TITLE V RENEWAL PUBLIC COMMENTS AND AQMD RESPONSES
Quemetco, Inc., Proposed Draft Permit Dated November 18, 2005

Comments and responses regarding Quemetco's Title V permit renewal are found on the following pages, divided into several sections. Each section identifies the source, mode and dates in which the comments were received. In many instances, comments received from different sources were similar or identical. In these instances, such comments are answered in only one of the following sections. In other instances, related comments were combined into one comment and again are answered in one section only. All references cited can be found in Appendix B immediately after the finish of the comments and responses.

ANALYSIS OF VARIOUS STEAM PLUME CONFIGURATIONS

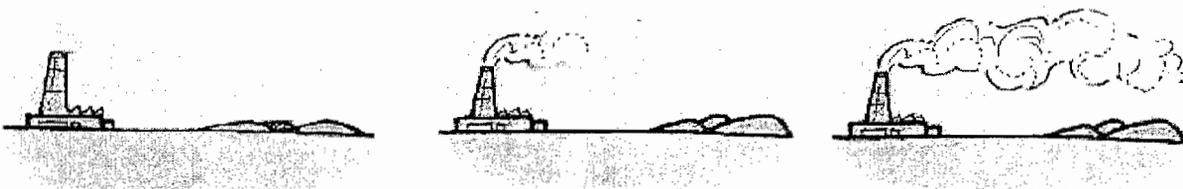
<p>B2</p> <p>Photographic evidence of stack emissions shows that when the tests were performed on the rotary dryer, it was in no way indicative of what comes out of the stacks during "normal operations." The tests also do not measure cases where material impinges on the flame in the dryer.</p>	<p>The submitted photographs have been examined and, based on AQMD staff's engineering experience, the visible emissions in these pictures appears to represent condensed water vapor (steam).</p> <p>The absence of these visible plumes during source tests can be explained by the fact that</p>

A detailed graphical analysis of possible steam plume configurations has been performed and the results are indicated in the following two psychrometric charts:

In these two charts, a steam plume is indicated whenever a system line (i.e., lines between Point A and Point B) exists to the left of the 100% relative humidity curve. The situation for a low stack moisture concentration (Chart #2) is represented by the following three illustrations:

For the high moisture situation (Chart #1), there will always be a visible steam plume from the reverberatory furnace stack. Based on this technical analysis of the situation at Quemetco, there is a very high probability that the images of visible plumes submitted by Mr. Duncan McKee represent condensed water vapor (i.e., steam) at different conditions. This conclusion is further supported by the fact that the submitted images show that whenever there is a plume, the plume comes to a sudden and abrupt end -- characteristic of the point where the water droplets suddenly evaporate at the point of less than 100% relative humidity. As indicated above, there will be times when visible plumes do not exist during normal operation of the reverberatory furnace.
